Comments on Planning Applications 2021/1089 and 2021/1090

Many of the documents are the same, if with different filenames. Comments are common to both if appropriate.

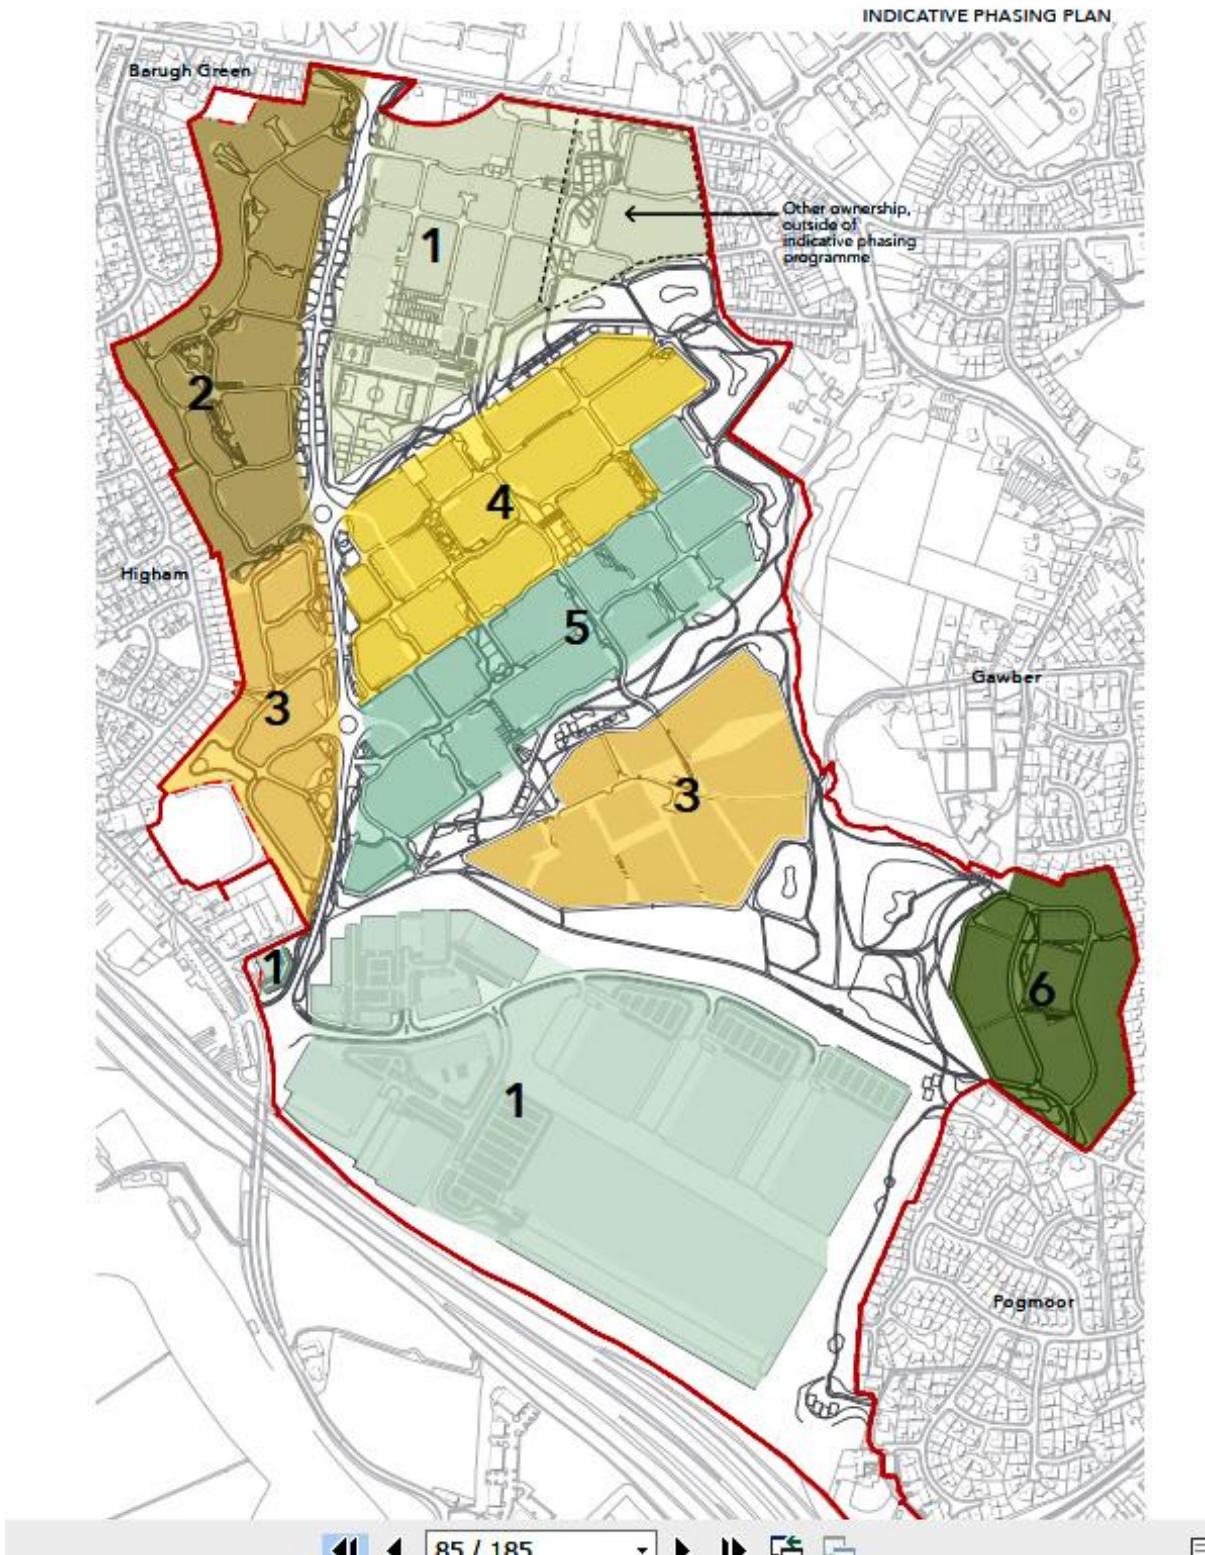
4.44 Maximum building heights are illustrated for each land use on the Parameters Plan. ... consideration of the existing residential areas surrounding the site. It is assumed that the building heights across the residential element of the site would be up to 3 storeys (up

to 13.5m in height). See above even 2 storey properties are unacceptable in areas where existing properties are single storey.

[ENVIRONMENTAL STATEMENT – Non-Technical Summary](#)

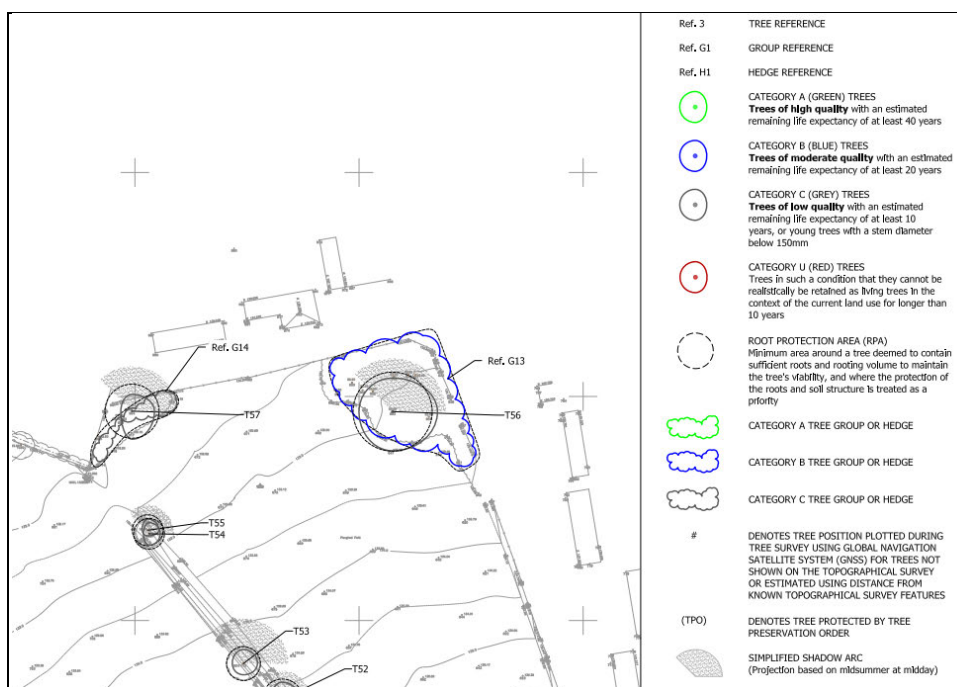
26. The results of this assessment have indicated that the potential environmental effects resulting from the increase in traffic generated by the development are predicted to be minor or negligible and not significant. Contradicted by the statement below and the extensive amount of “mitigation” required for noise detailed in the Noise chapter.
